MODIFICATION REQUEST:

Project Application for Mixed Use Development

45-47 Macquarie Street and 134-140 Marsden Street, Parramatta

Secretary's Environmental Assessment Report
Section 75W of the
Environmental Planning and Assessment Act 1979

Figure 3: Comparison between the approved (left) and proposed (right) Hunter Street elevation (Base source: proponent's EIS and RtS)

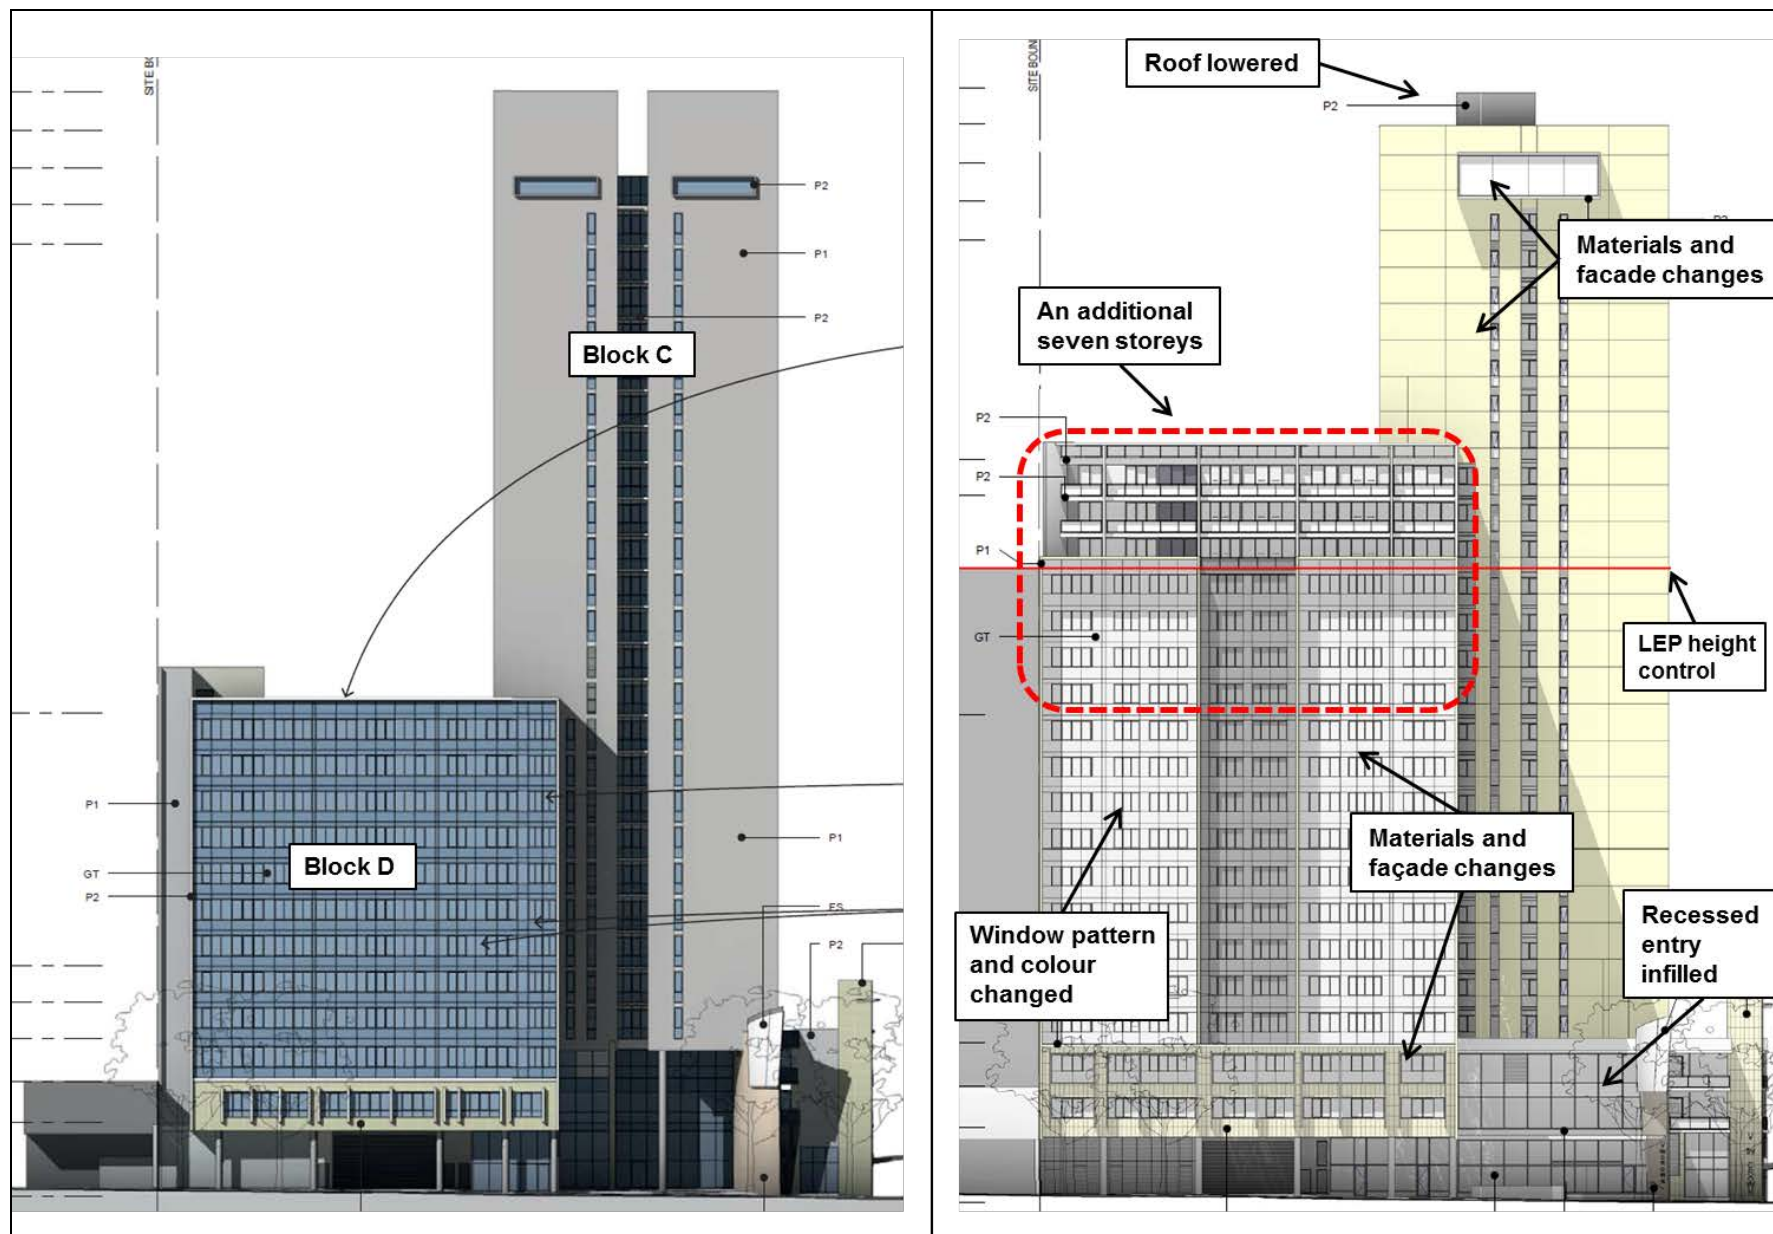
Council raised concern that the design of the Hunter Street elevation of Block D lacks compositional clarity and the distinction between the taller and shorter elements of the development has been diminished.

In response the proponent amended the proposed Hunter Street elevation of Block D by setting back the top three floors, dividing the Hunter Street elevation into three vertical parts and providing dark glazing within the central part of the elevation to mimic the visual break / gap between Blocks B and C on Marsden Street.

The Department considers that the revised architectural composition of the Hunter Street elevation is adequate for the following reasons:

Figure 4: Proposed revised FSR controls and removal of height controls (Base source: Parramatta CBD Planning Strategy)

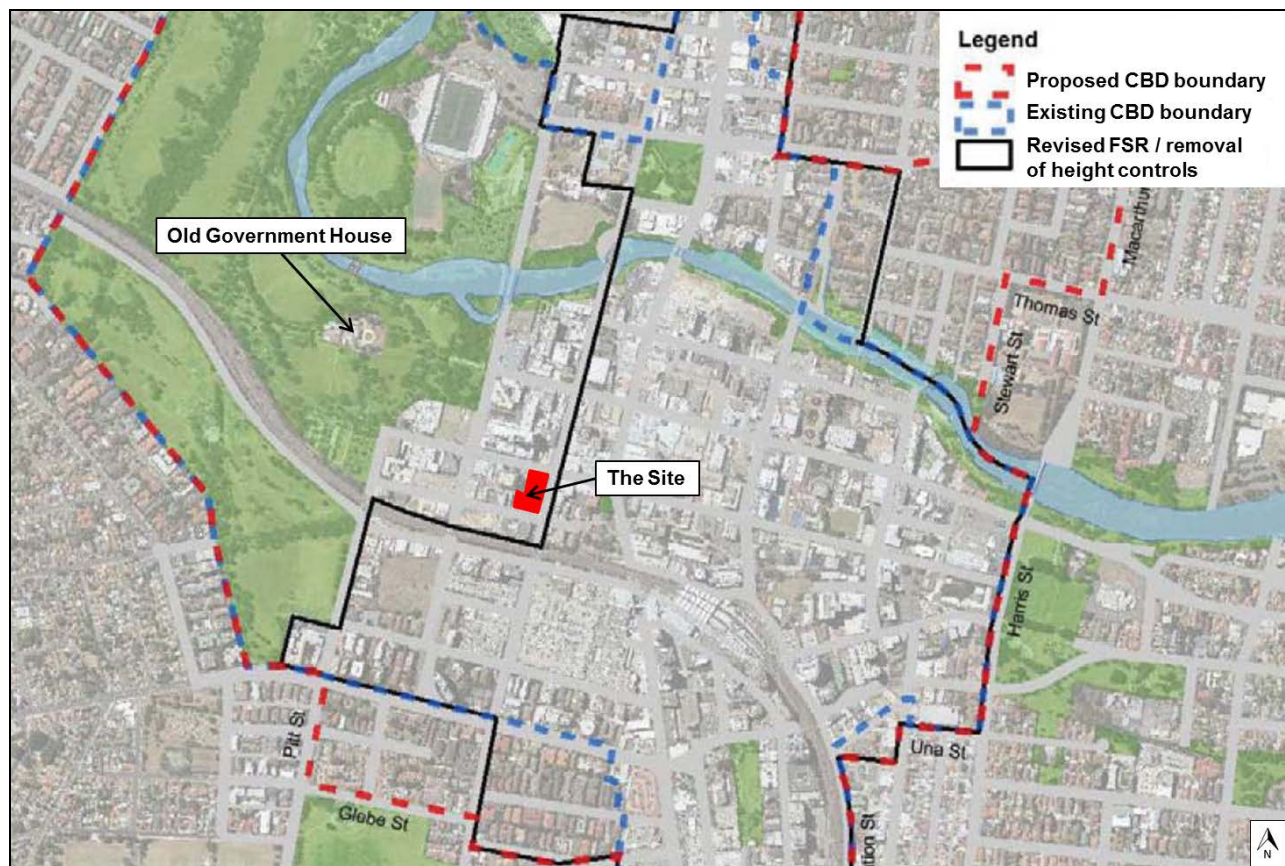
As outlined in **Section 2.2**, Council is investigating increasing the FSR (to 10:1) and removing height controls for most of the Parramatta CBD (**Figure 4**). However, Council proposes to retain the existing FSR and height controls at the site, and surrounding blocks, due to its proximity to the OGHD. Notwithstanding this, Council has raised no objection to the proposed height and increase in GFA as it is consistent with the broader future strategic direction for the city and raised no objection to the proposed increase in height in this case.

The Department is of the view that the increase in GFA and provision of an additional seven storeys is acceptable as the proposed:

Figure 9 Signage zone (left) and Crown logo sign (right) at roof level (Source: proponent's RtS)

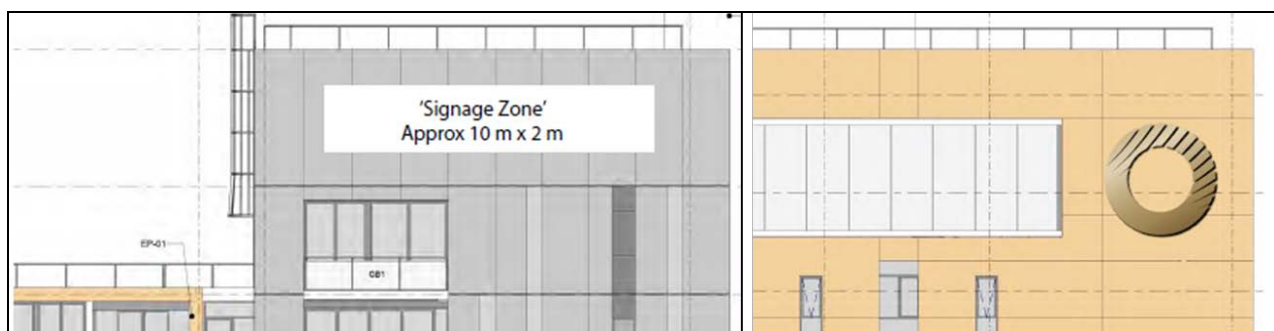
The Department considers that the roof level signage zone and Crown logo sign are acceptable and proportionate to the scale of the development. Further, the proponent has indicated that the roof level signage zone is expected to contain halo-lit lettering and therefore would not fill the entire expanse of the proposed 20m² signage zone.

Figure 10: Support column mounted retail box signage zones (left) and hanging retail box signage zones (right) (Source: proponent's RtS)

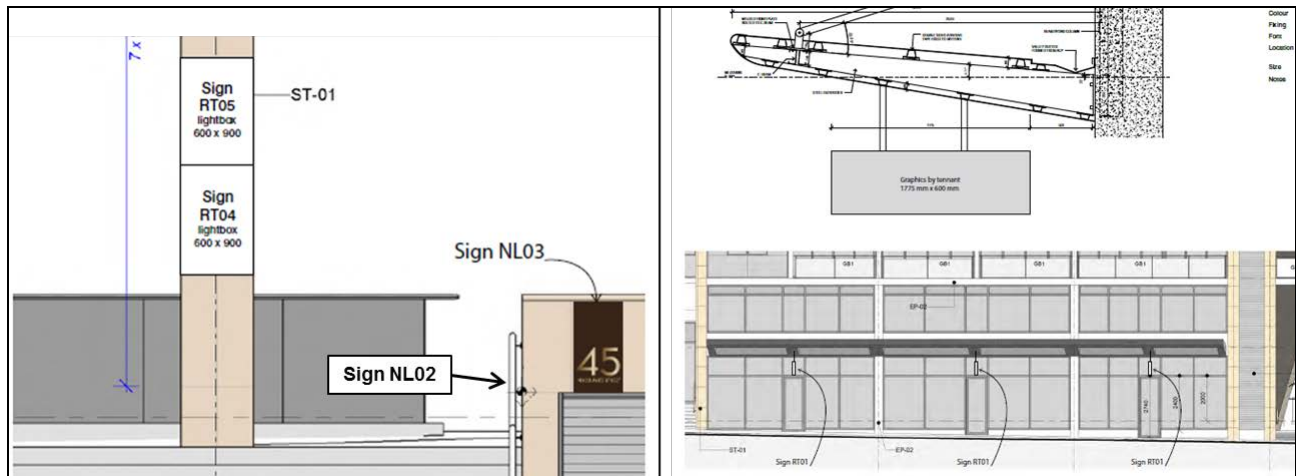
The Department notes that there are four proposed signs in close proximity to each other at the Macquarie Street entrance, comprising two internally illuminated retail box signage zones

mounted on the building support column at the northern lobby (refer to **Figure 10**) and two building identification signs. The Department considers that the proliferation of signs in this location may result in visual clutter when considered together and in the context of the pedestrian environment. The Department therefore recommends a condition requiring the deletion of one of the internally illuminated signage zones.

Other than the retail signage zone discussed above, the Department supports the proposed signage as it satisfies the key assessment criteria in SEPP 64 (refer to **Appendix B**). In particular:

Figure 11: Proposed roof top bar (coloured blue) at level 26 of Block C (Source: proponent's RtS)

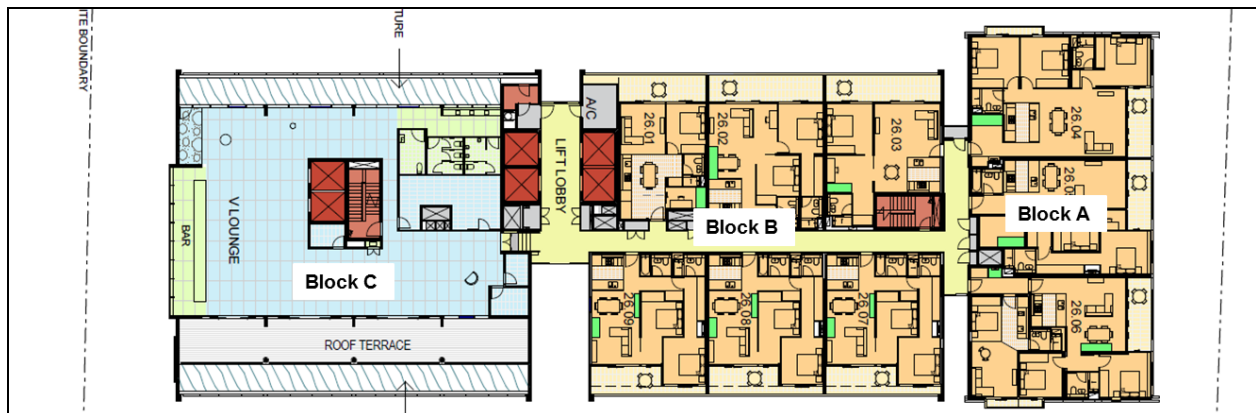
The proposal includes the provision of a roof top bar, referred to as the V-Lounge, at level 26 of Block C (refer to **Figure 11**) and a roof terrace fronting Marsden Street. Operational details of the proposed bar are provided below:

Council is satisfied with the proposed capacity, hours of operation and access to the bar provided that the overall operation does not give rise to adverse impacts on residential amenity and security. The Department has reviewed the Plan of Management submitted with the proposal is satisfied that adequate measures can be implemented to ensure that the bar does not affect residential amenity. The Department therefore recommends a condition relating to the operation of the rooftop bar that ensures the:

- bar is operated in accordance with a management plan;

- operation will not give rise to unacceptable noise impacts;
- hours of operation are not outside of 7am and midnight;
- dispersal of patrons does not have an adverse impact on amenity; and
- access from the bar to the residential circulation area at level 26 is only possible in event of emergency.
